Building Permit Application

Existing Use: RESIDENTIAL
Proposed Use: Deck
Estimated Construction Cost: \$ 12,000
Description of Work: Deck

PROPERTY ADDRESS: 846 RIDGE ROAD, MOUNT AIRY, Maryland 21771

DECK FRAMING PLAN

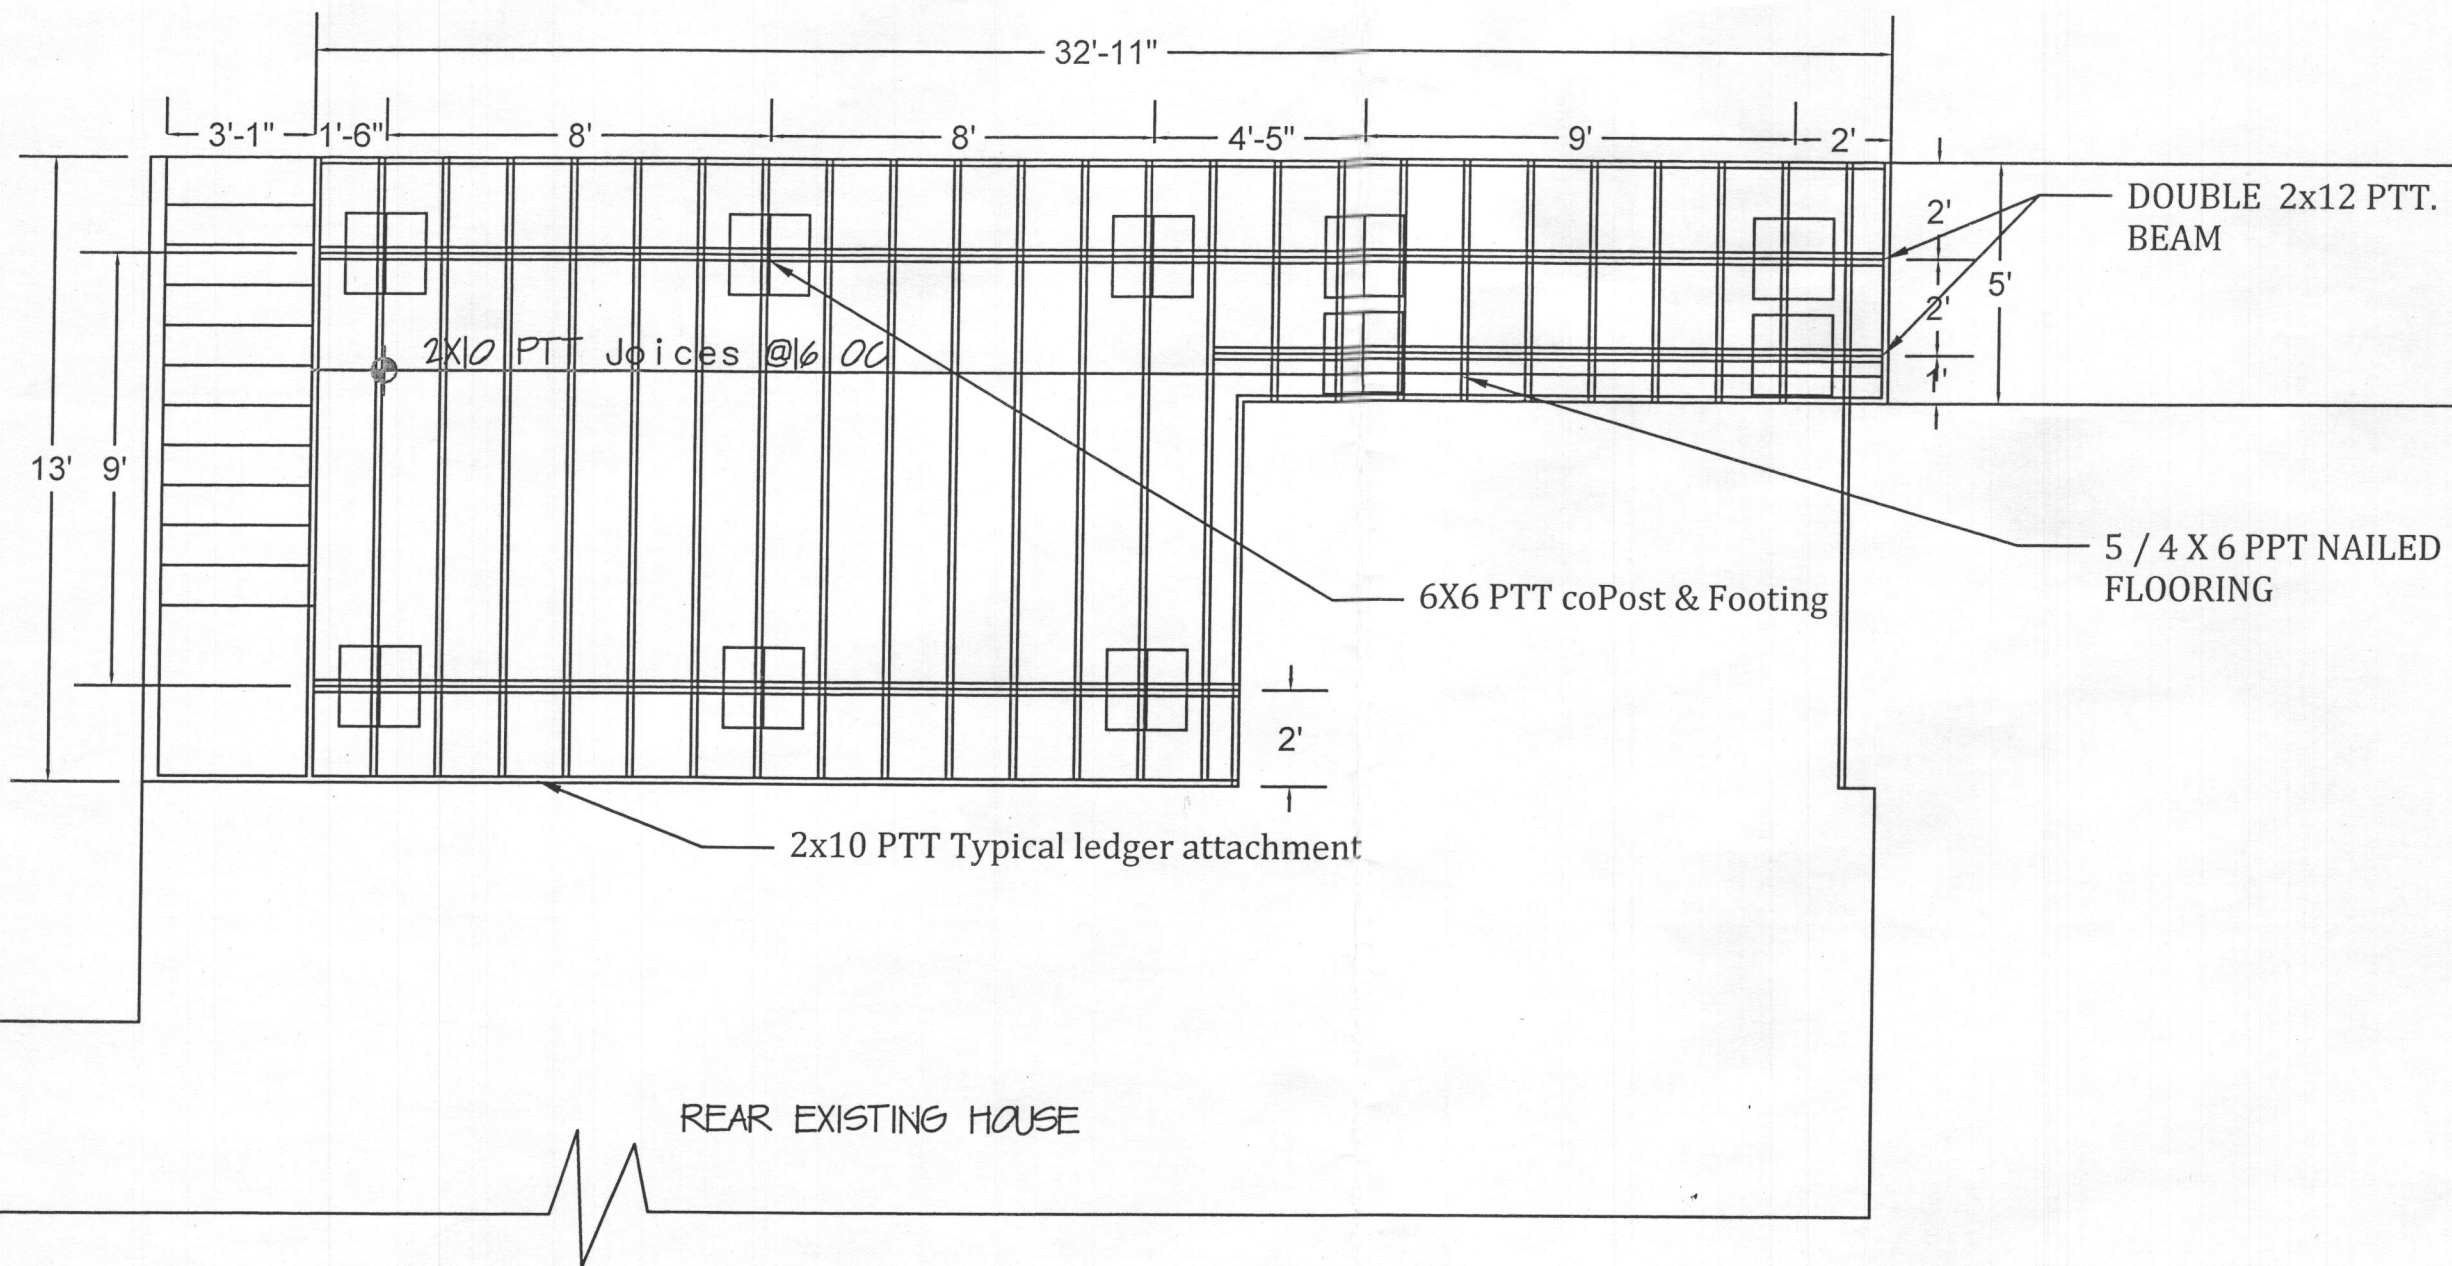
I apologize for the typo it should be 13 on the one side.

I am the homeowner you owner of 846 Ridge Rd. Mount Airy, MD 21771. I request the waiver for our deck. That will be 5' in left side and 12' in the right by the 32'11 wide. Please contact me with any questions. 443-794-0063.
Thanks.

7/6/17
Approved
Richard J Davis
No waiver required
Deck ≥ 5' from deck
RJD
